Memorandum to the City of Markham Committee of Adjustment

June 5, 2018

Files: B/36/17, A/135/17 and A/136/17
Address: 21 Lanor Court, Markham
Applicant: Samithamby and Shivanthini Harichandran
Agent: QX4 Investments Ltd. - Consulting Services
Hearing Date: June 13, 2018

Figure 1 - Site Location and Area Context

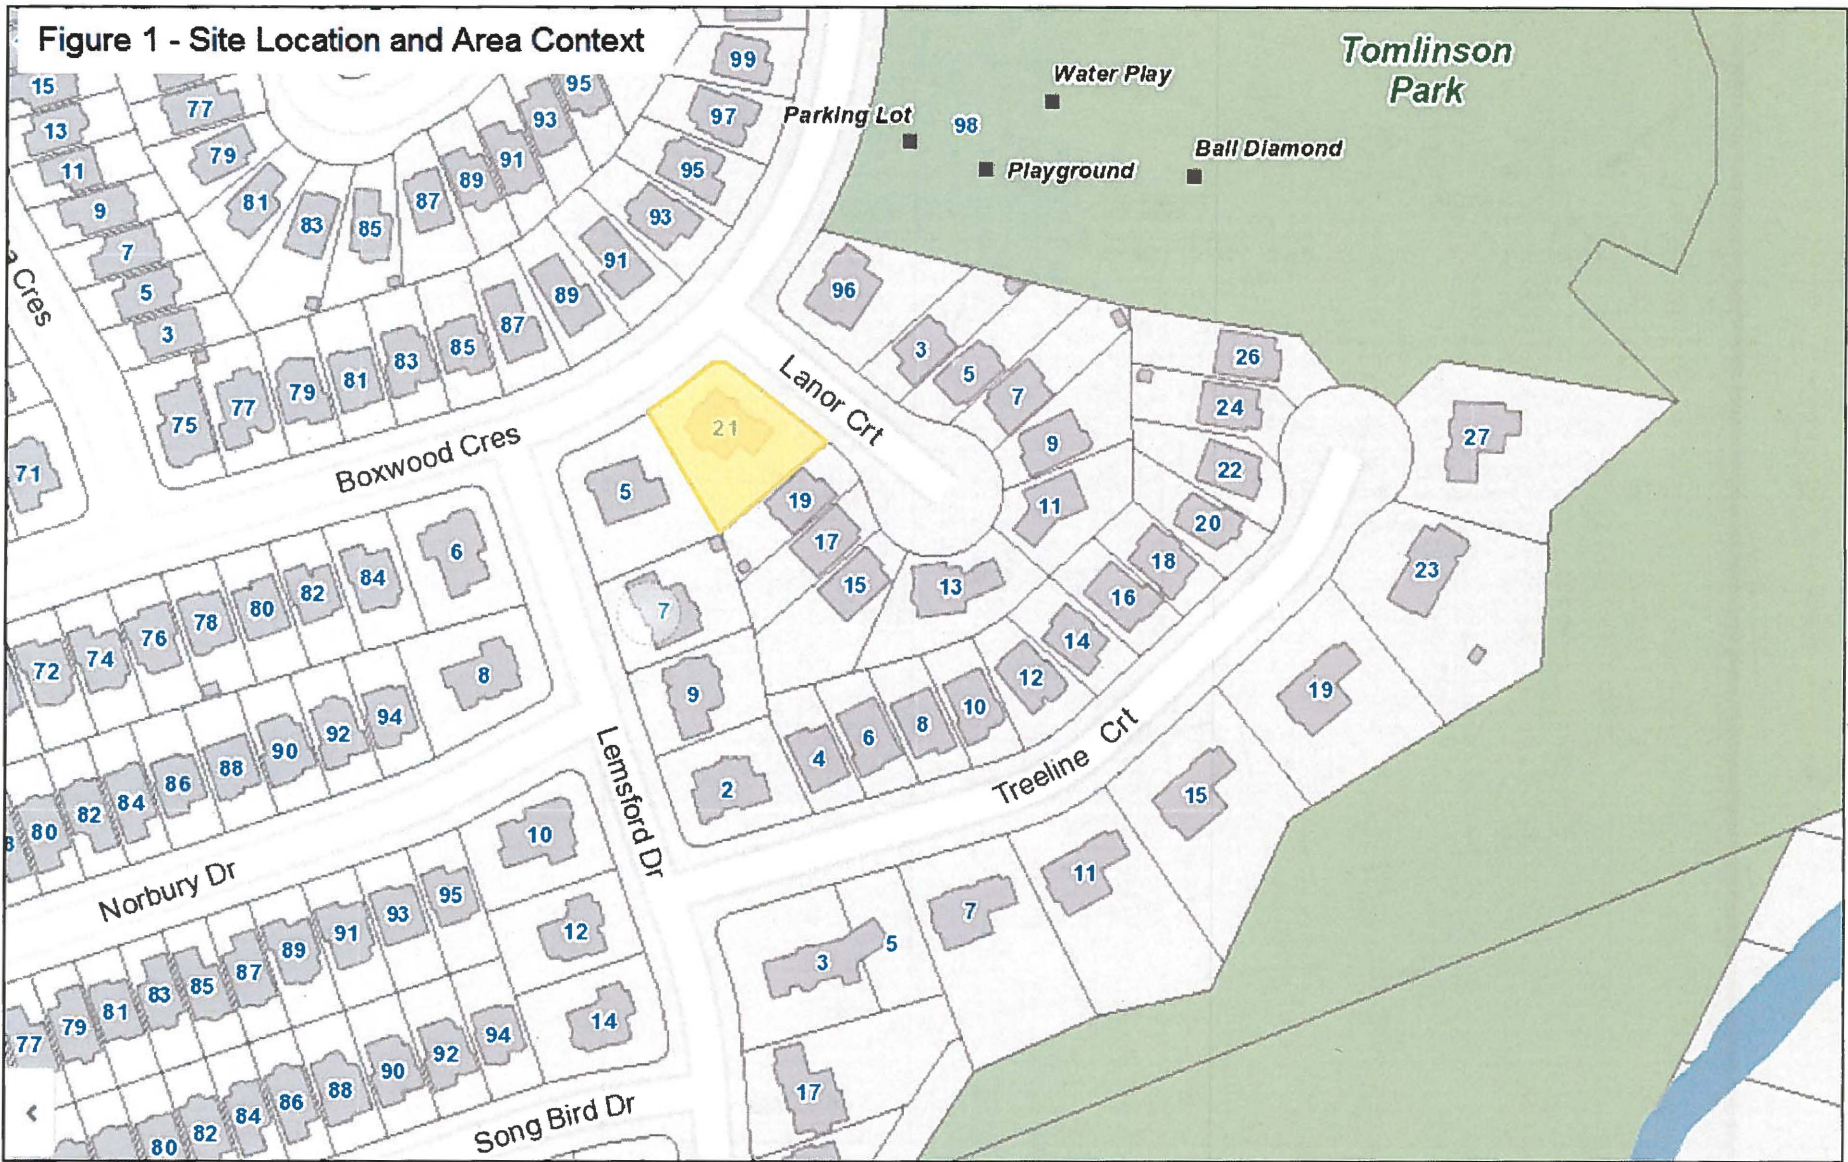
Figure 1 shows the subject site and the surrounding area context. The lot pattern of the surrounding area varies and is characterized by a diversity of lot areas, frontages and configurations. It is staffs opinion that the proposed 'severed' and 'retained' lots are compatible to existing lots in the surrounding area and that the creation of a new lot will have minimal impact on the community. Staff recommend approval of the proposed

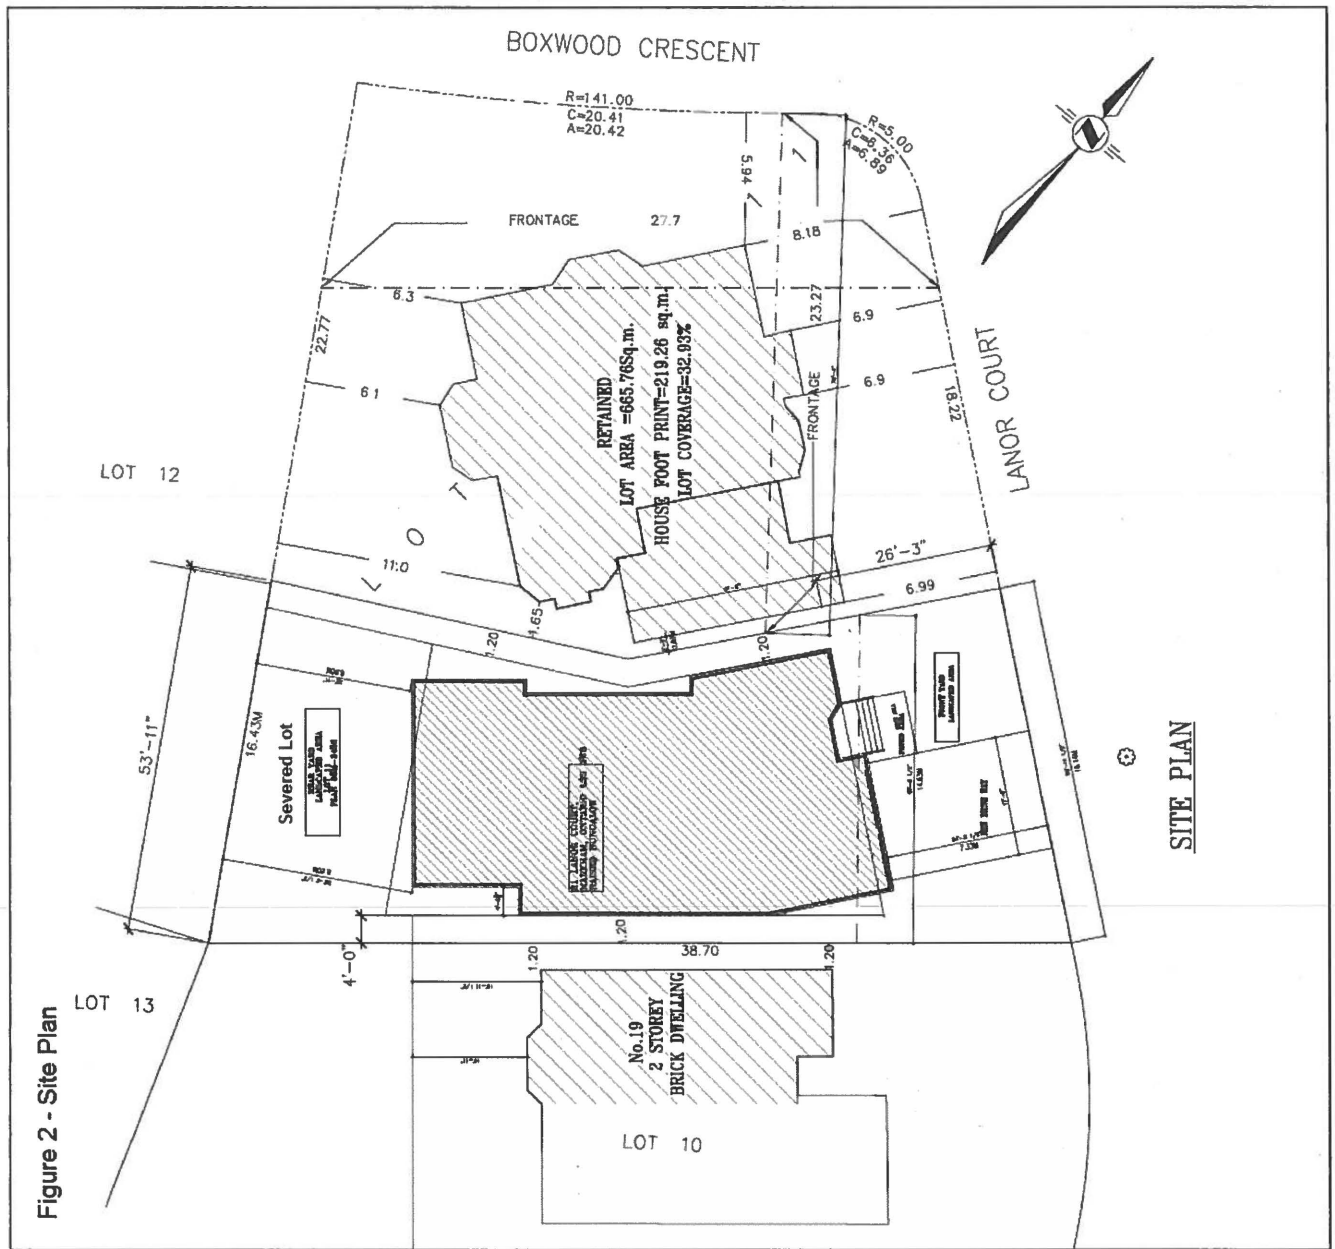
To ensure that the variances relate to the dwelling as proposed, particularly as a predominantly one storey building, staff recommend a condition that any approved variances for the 'severed' lot reflect the plans submitted with these applications and shown on Figure 2. Similarly, staff recommend a condition that approval of the requested side yard setback reduction apply to the south side yard only, as reflected on the plans submitted with this application (Figure 2).

Figure 4 - Front Elevation - Proposed Dwelling
'Severed' Lot

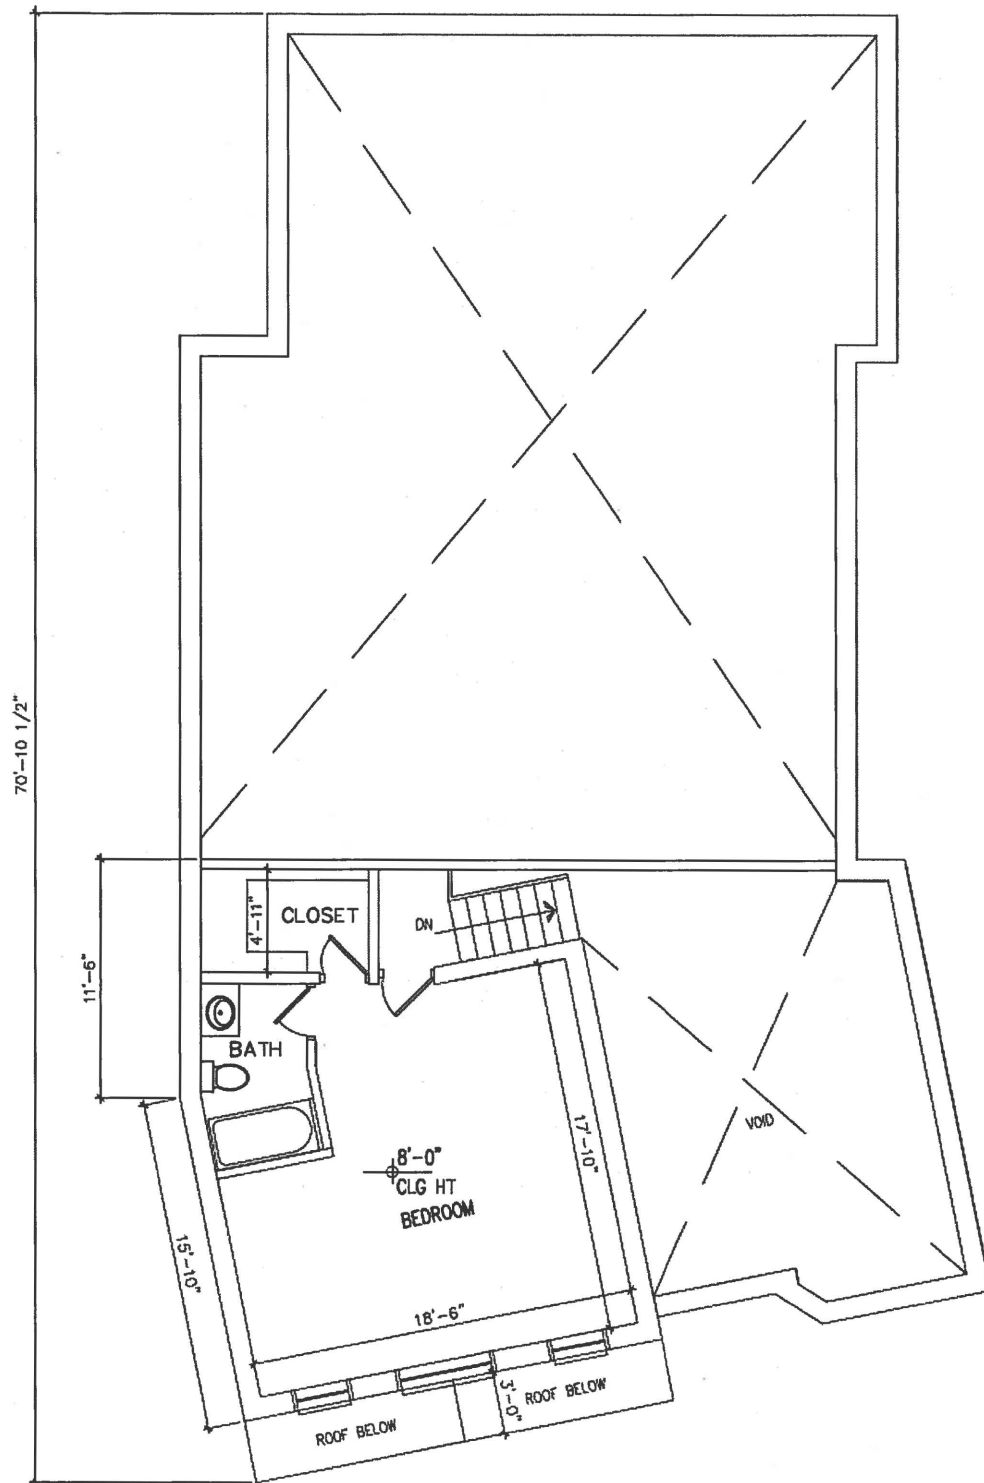
On May 17, 2018 the applicant resubmitted their revised proposal to address the comments described above. The resubmission addressed resident comments to reflect a home that is more compatible to the style and massing of existing homes. The revised submission provides a larger front yard setback between Lanor Court and the proposed dwelling to address site line concerns.
